**Bulletin #** BU-932

## SERVICE BULLETIN

Ride Name: StarTrooper

AIR BRAKE LINES

**EXHIBIT A CORRECT  
VIEWED FROM REAR BUMPER**

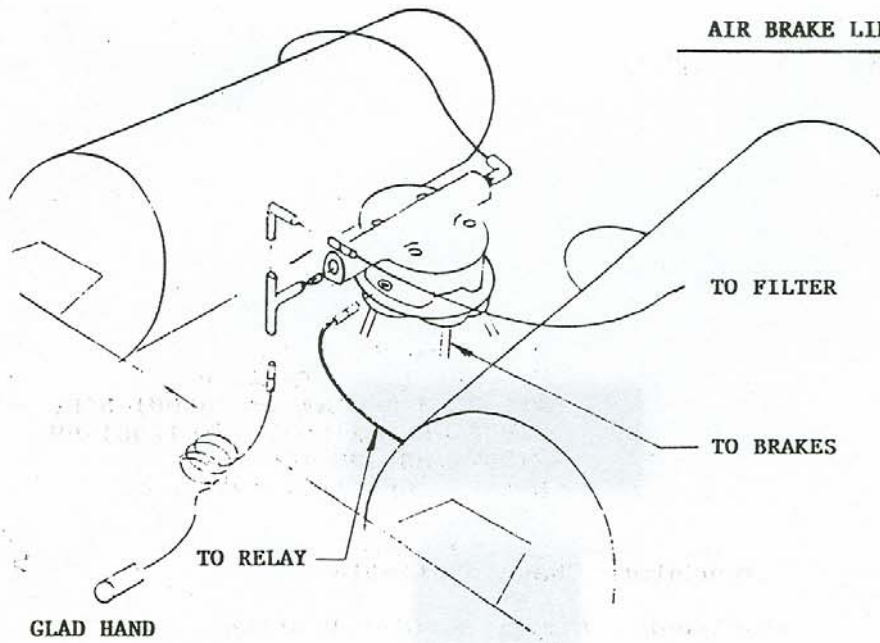
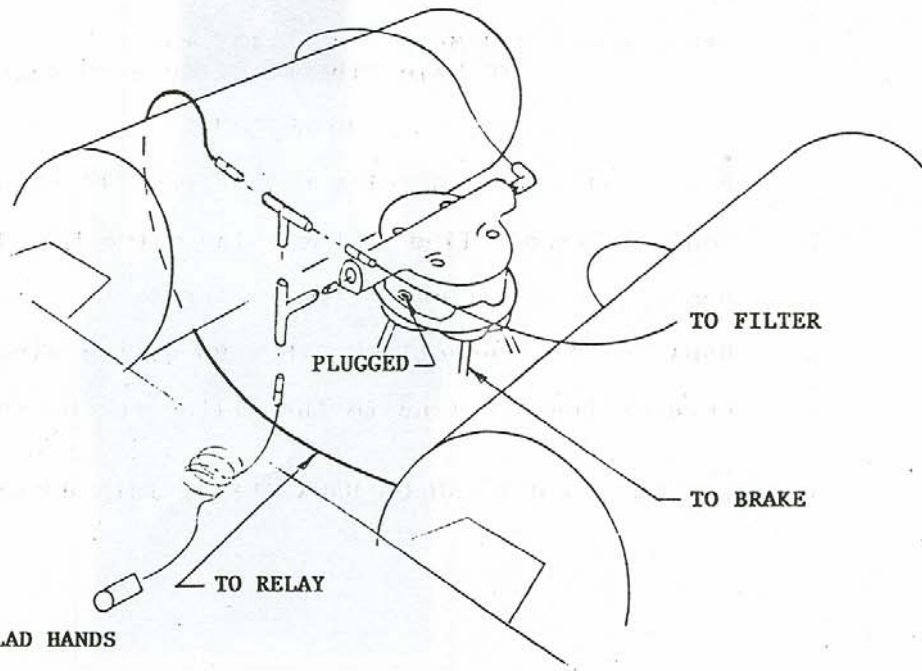
**Summary of Issue:** Please review the attached drawing. If the spring break valve on your StarTrooper is plumbed like Exhibit B change the plumbing to match Exhibit A.

**Reason for release:** It is possible that the trailer brakes on some StarTrooper's were incorrectly plumbed. The incorrect plumbing does not effect the operation of the trailer brakes. However, when the StarTrooper is disconnected from the tractor air will not be trapped in the holding tank. Several minutes will be required to build up air in the tank before departing. Changing plumbing to the configuration of Exhibit A will correct this problem.

**Parts required:** 3/8 Male Pipe x 1/2 tube  
3/8 Male Pipe x 1/2 tube 90 degree

1. Remove airline to relay valve from "T" connection.
2. Connect the airline to relay valve into plugged port.
3. Remove the airline to the filter from "T" connection.
4. Replace "T" connection with a 90-degree elbow.
5. Connect the airline to the filter to the 90-degree elbow.
